SOUTH FLORIDA WATER MANAGEMENT DISTRICT

LAN 08-02
1010/C-4

November 6, 2014

SUBJECT: BT904-UCPP/TIGER-Florida International University (FIU) –Conceptual Skywalk Bridge Plans crossing C-4 and SW 8th Street, Miami-Dade County, Section 6/7, Township 54S, Range 40E

TYPICAL SECTION

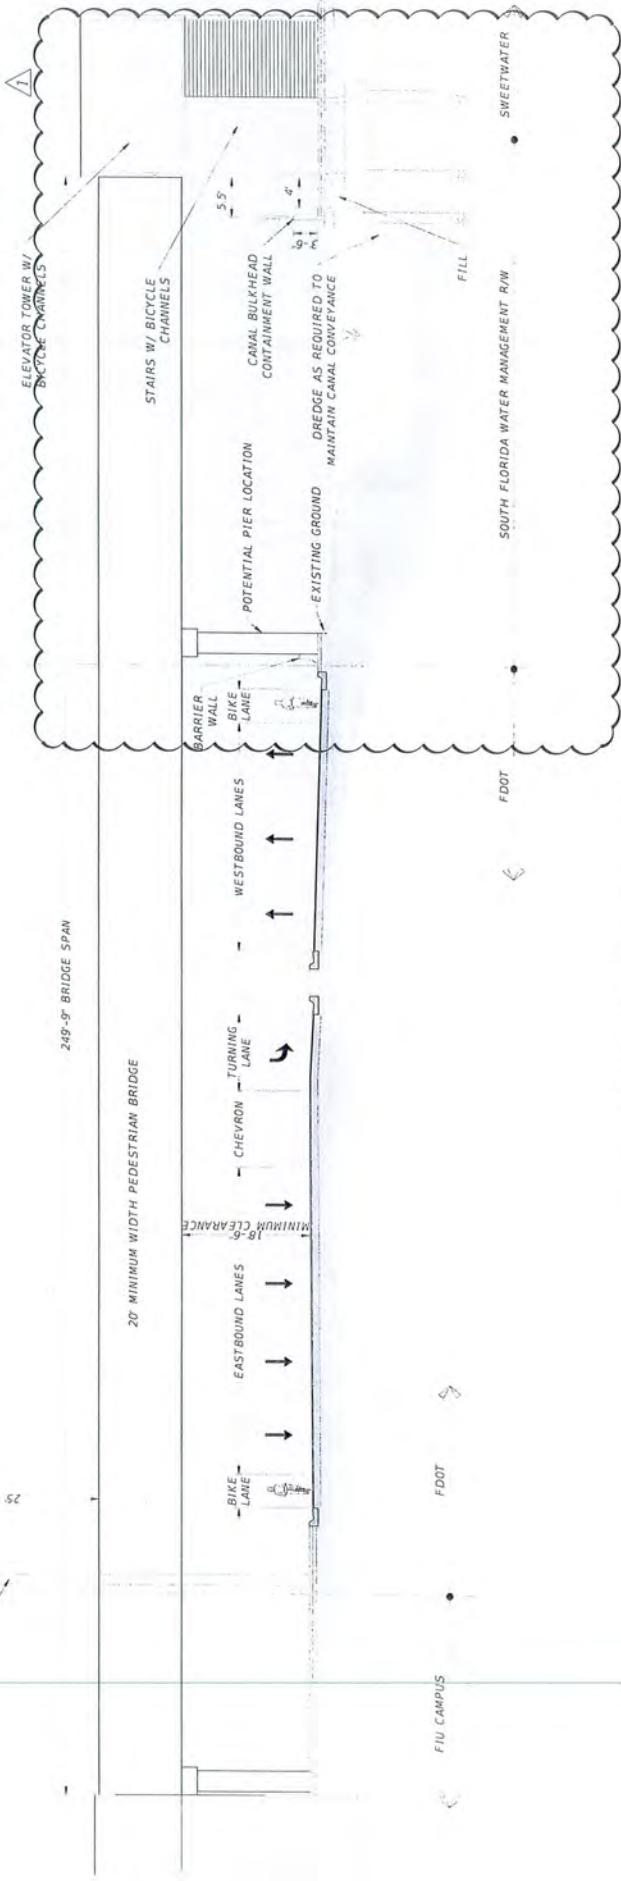
RELOCATE (3)
TRANSMISSION POLES W/
25' CLEARANCE FROM TOP
OF THE BRIDGE TO LOW
WIRE
